Ootacamund Lake

The proposals of the Chief Engineer, Public Works Department, in regard to increasing the depth of the lake-supply channel and lowering the level of water in the —, accepted with remarks.

NOTE ON THE OOTACAMUND STREAM, being the source of supply of the Ootacamund Lake.

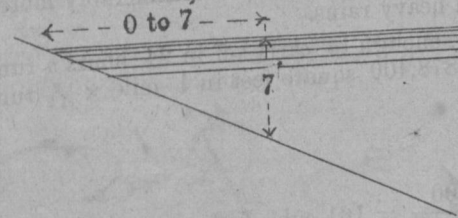
(a) Reduced area, but this is really infinitesimal and when the brown area round the margin is covered with vegetation will not be noticeable.

(b) Spoiling the appearance of the lake. This is a matter of opinion I cannot say I could notice it to any appreciable extent.

(c) In crease of weed area. This sounded a plausible objection, but if the slope is continuous, as I believe it to be, it is not the case as if, as they do, weeds grow between nothing and seven feet of depth, that area is simply transferred low down.
